**LEGAL ADVERTISEMENT
HISTORIC PRESERVATION BOARD
CITY OF PORTLAND
Public comments are taken at all meetings.**

**PUBLIC HEARING
ADA PANEL INSTALLATIONS AT CROSSWALKS**

**PUBLIC HEARING
394 DANFORTH STREET**

**WORKSHOP
80-86 EXCHANGE STREET**

1 GARAGE LEVEL
Scale: 1/4" = 1'-0"

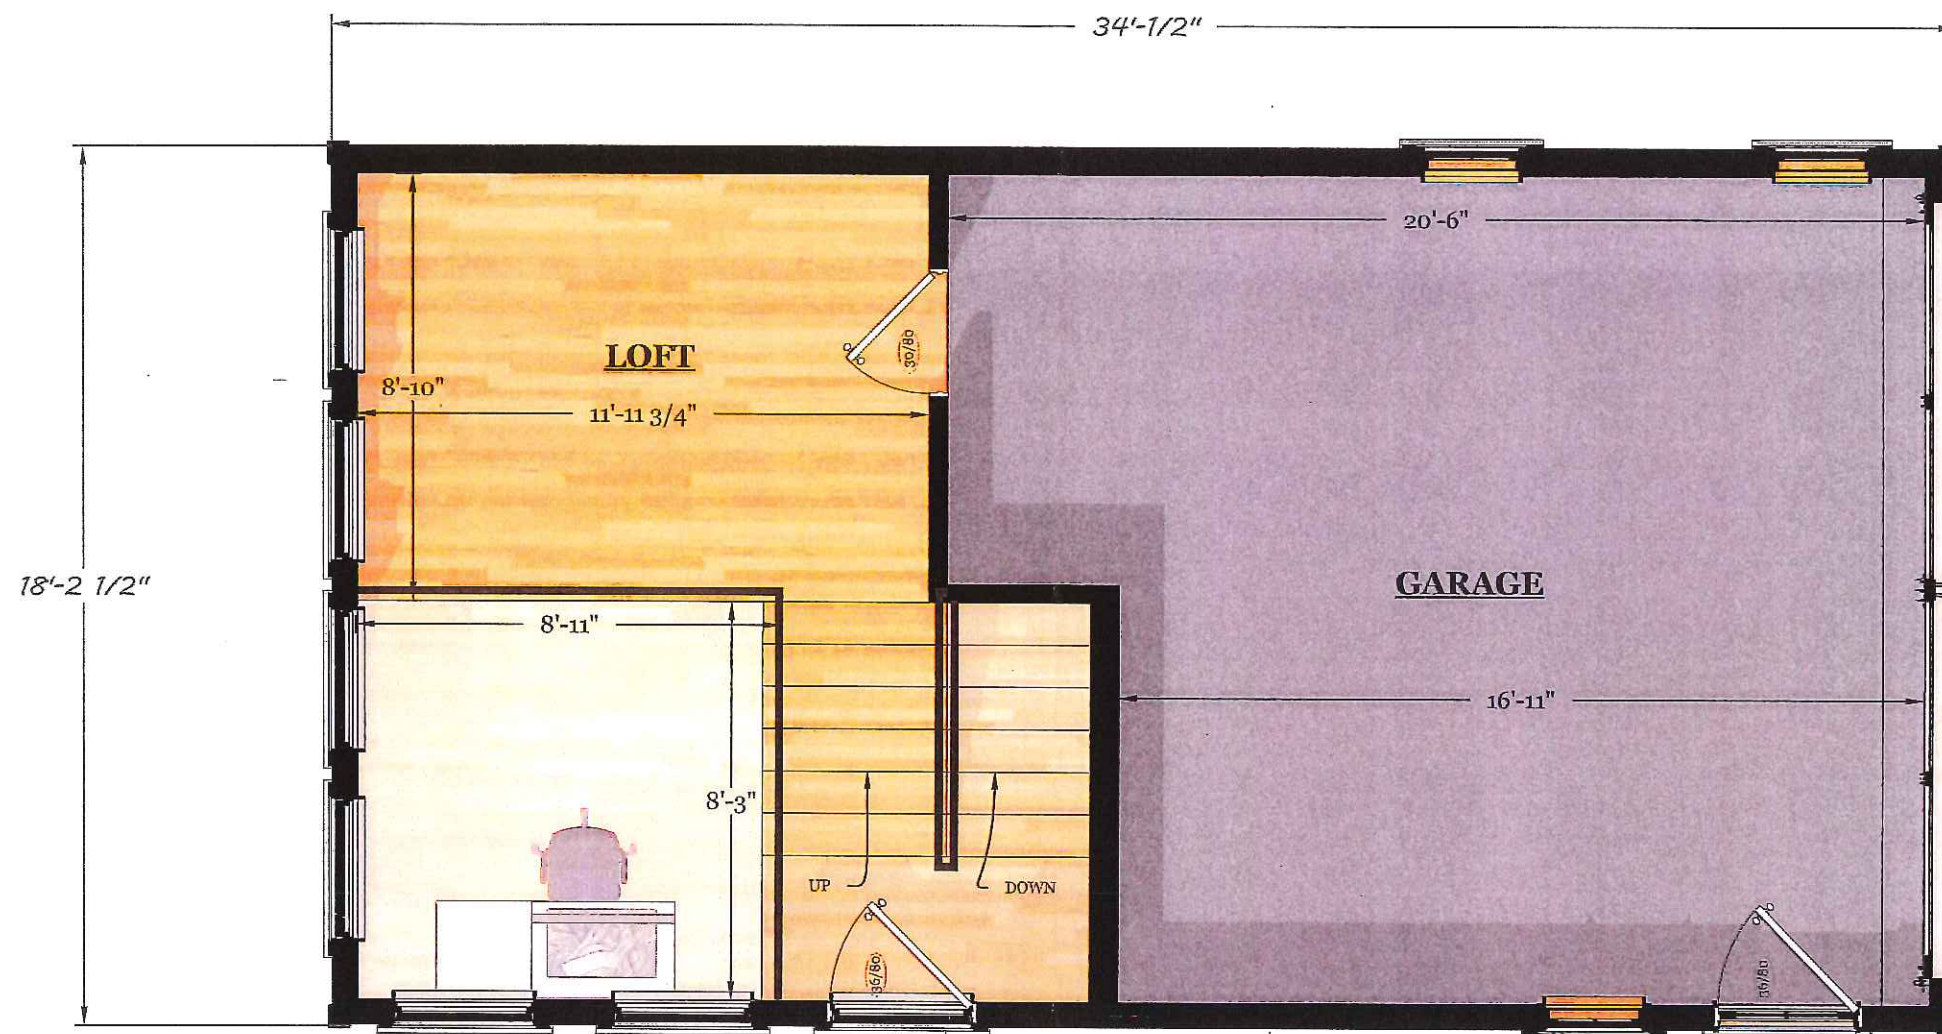
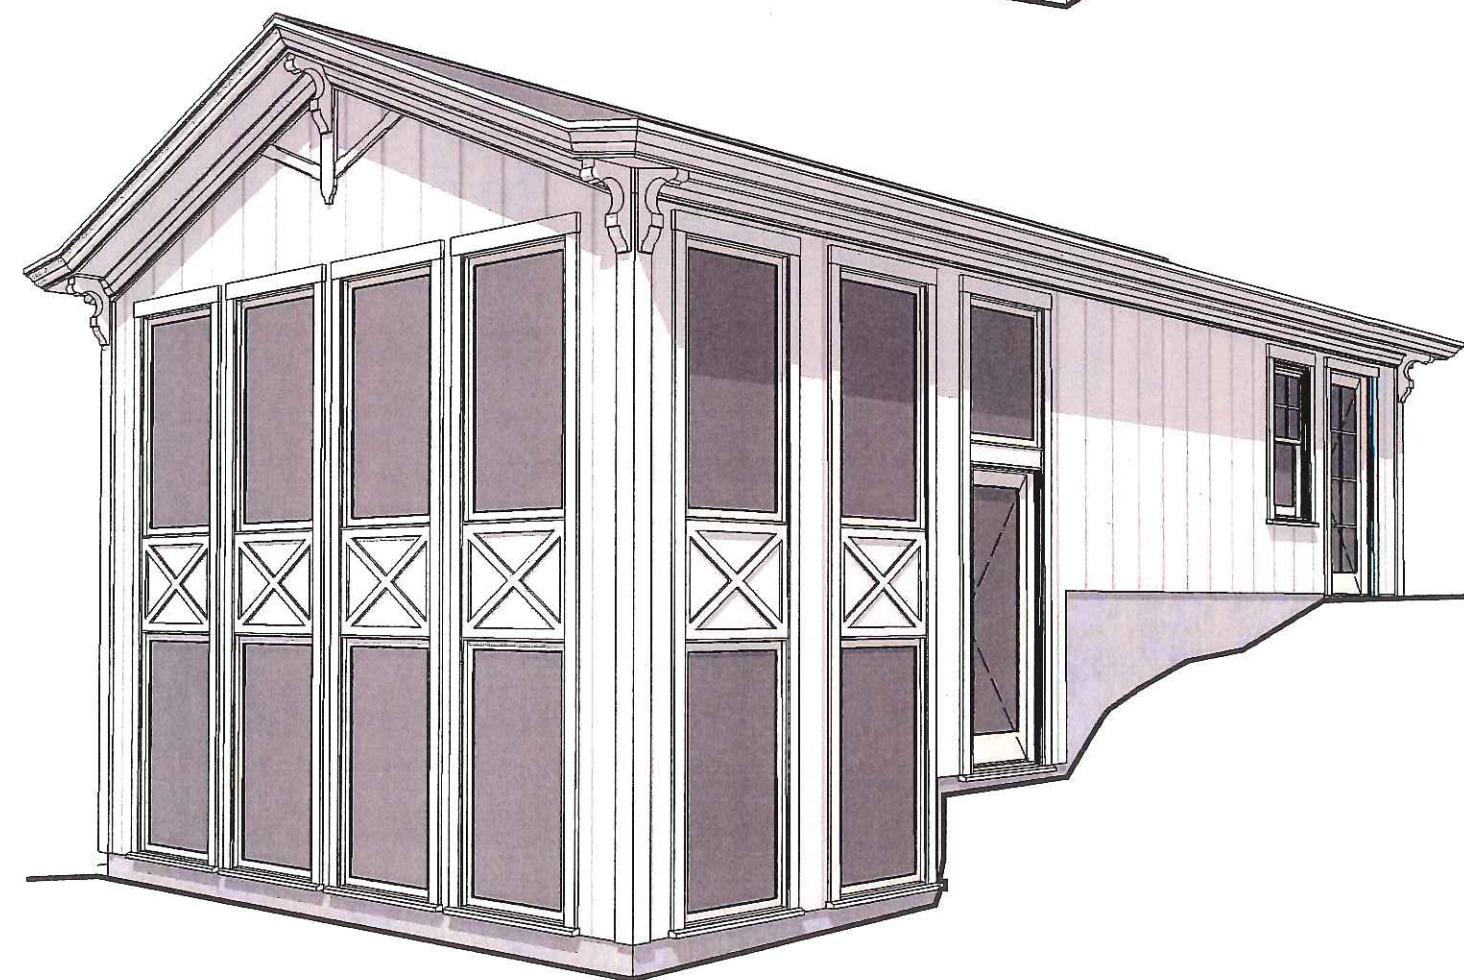
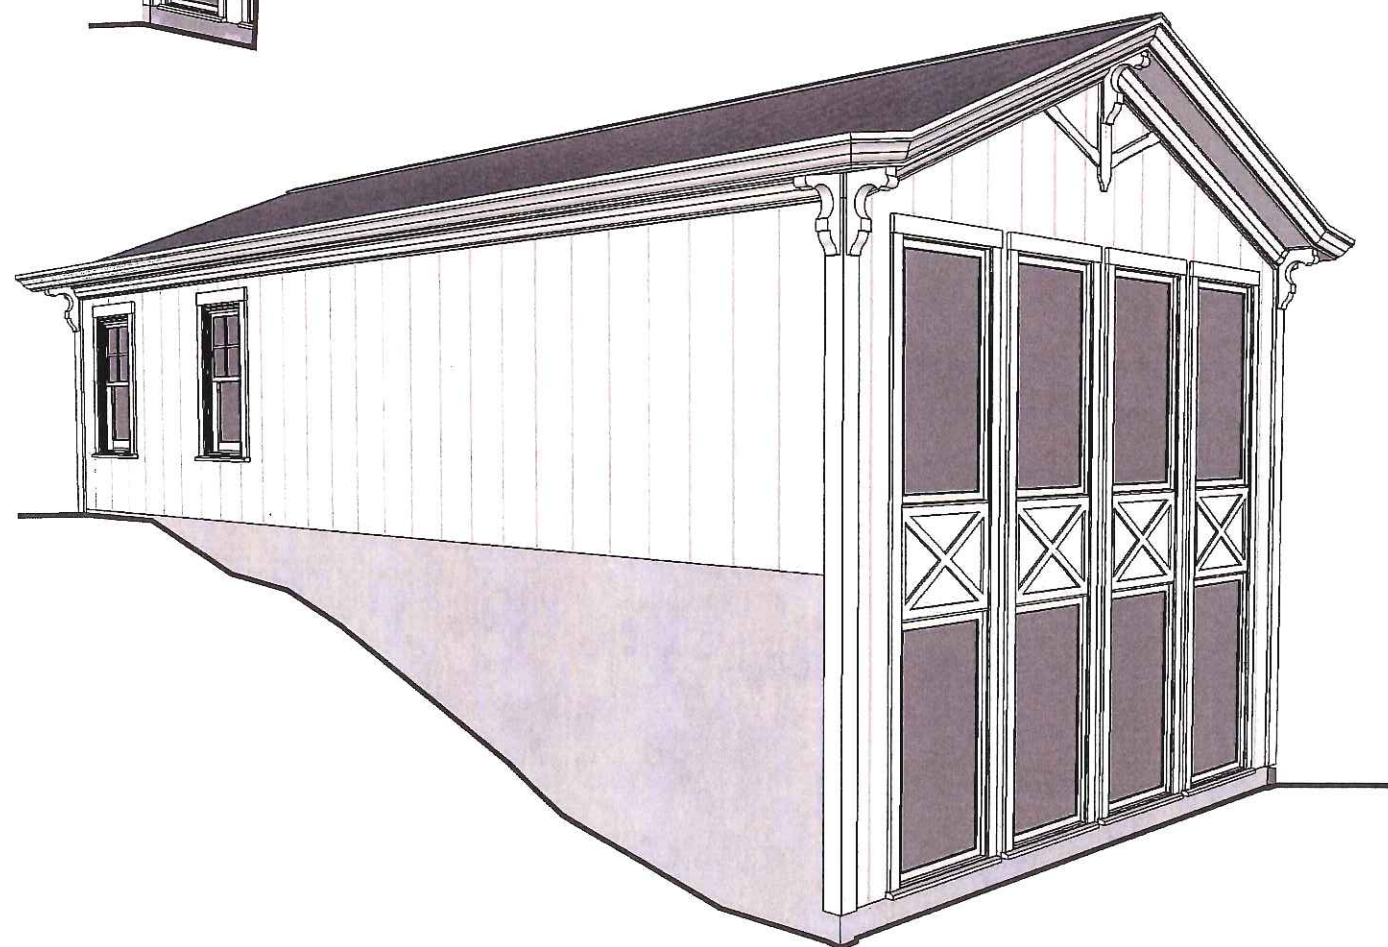
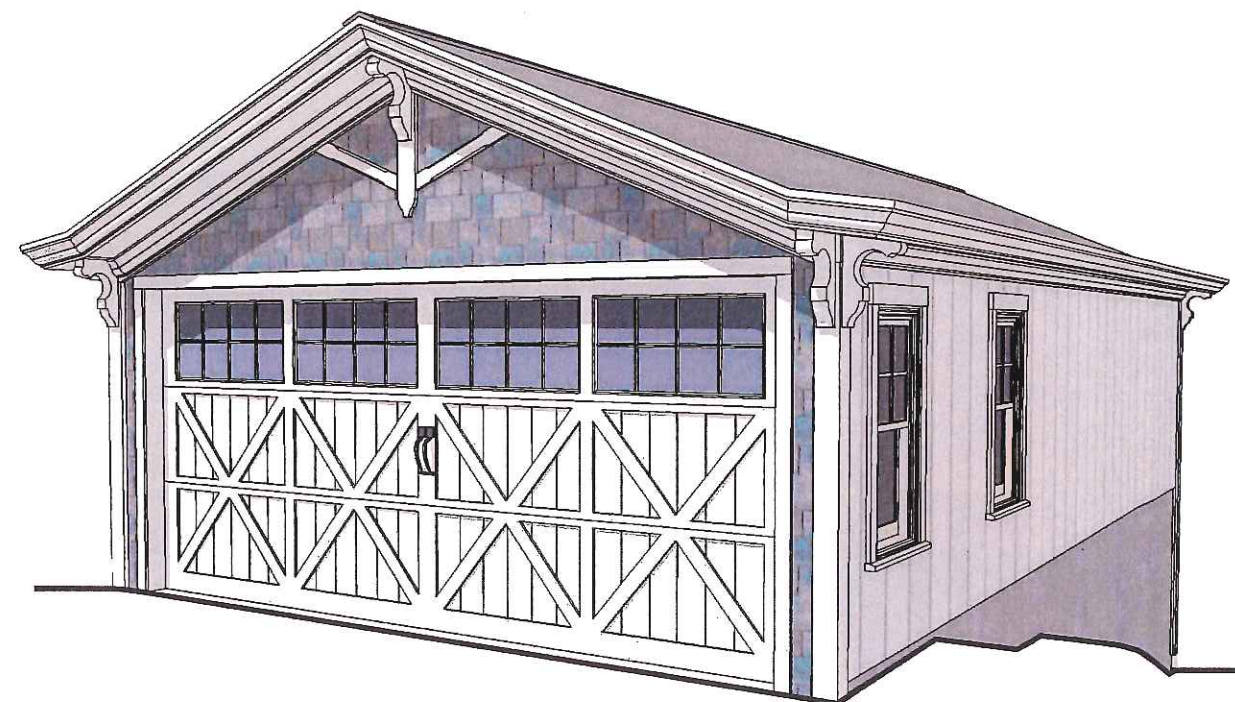
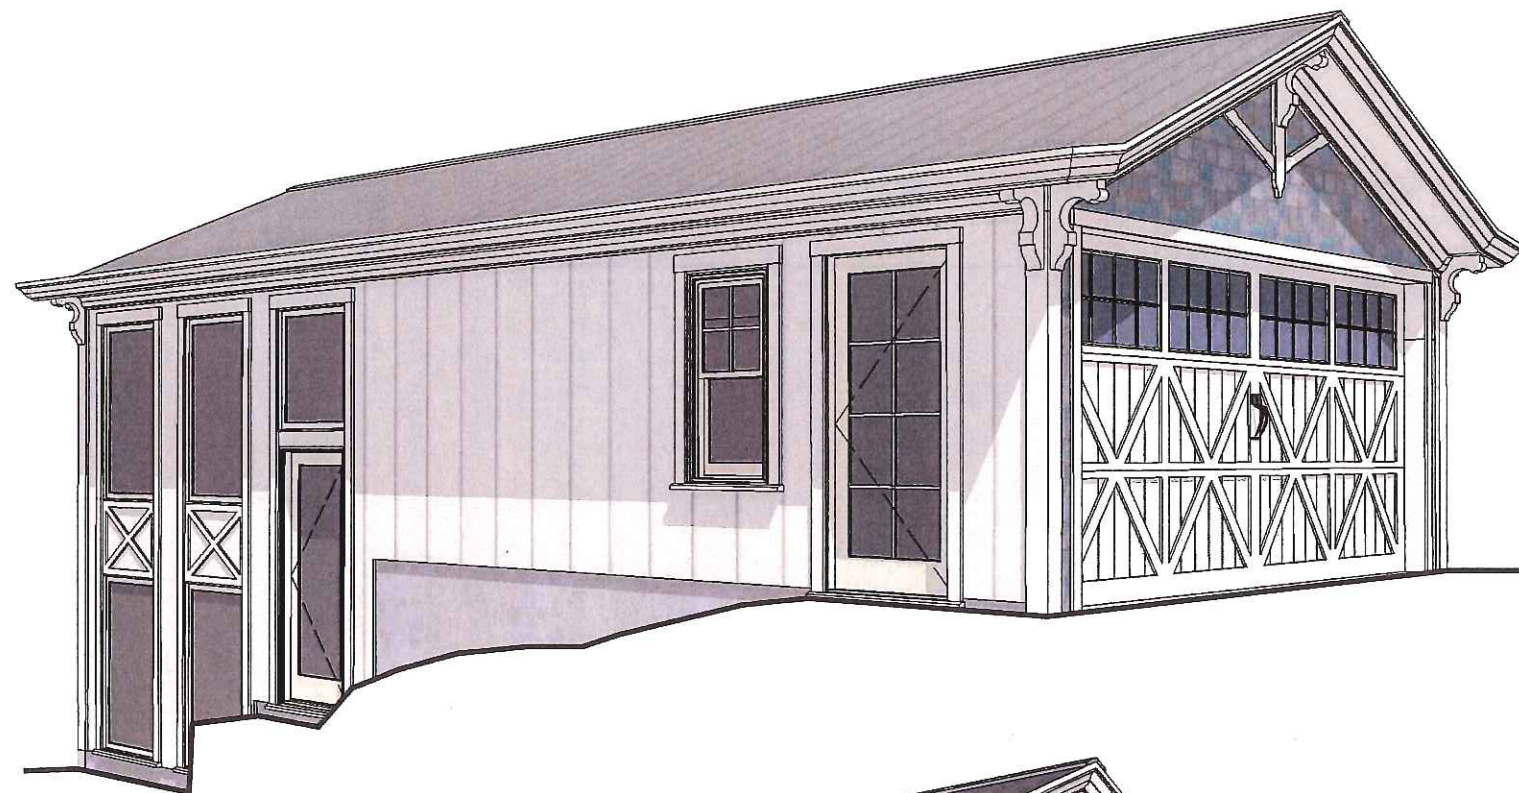
The only significant change proposed at the workshop to the shape of the garage was in the roof, where Mr. Valliere drew a 5/12 roof that flared to a flatter pitch at the eaves, echoing the flare on the roofs of the house. (The existing garage roof has a pitch of less than 1/12.) The proposed change in volume was minimal, because the designer lowered the wall height and raised the ridge to achieve the steeper pitch.

In addition to the flare in the roof, Mr. Valliere added several other details to decorate the garage, echoing in simpler ways the style of the house. These features included slate siding on the front, diagonals and windows on the garage doors, and brackets at the gable peak and eaves of the roof. The sides and back of the proposed garage were shown with board and batten siding, and toward the rear, considerably more fenestration than the existing structure has. The design included a replacement man door into the garage on the east side, and another door partway down the slope, to give access to the studio and the upper level loft. Proposed windows are clad units by Marvin, with double-hung, 4/1 units near the front of the garage, and large, one light units for the rear studio and loft.

- The roof pitch – Mr. Valliere proposed to raise the pitch to 5/12, with lower pitched flares near the eaves. Although at least one Board member indicated that the 5/12 pitch might be acceptable, several recommended exploring a lower pitch, and also recommended the eaves be kept relatively low.

- The slate siding on the front face – The slate siding on the house is a significant architectural feature, but there is no evidence it was ever a feature of the garage. There was a general feeling that adding slate might lend historicist gravity to a secondary structure. It was suggested that Mr. Valliere consider using board and batten siding, as proposed on the other three walls.

- Garage Door Design – While Board members did not object to the proposed addition of glass to the carriage-house-style doors, a number of them found the diagonal bracing too busy. Many diagonals are present in the trim panels of the residence, but with the exception of the subtle, diagonal flush boards in the panels of the existing garage doors, elaborate bracing and diagonal trim are not part of the present garage. Mr. Valliere's drawings show diagonally framed panels proposed between the windows in the rear of the garage, but these will not be visible from a public way.
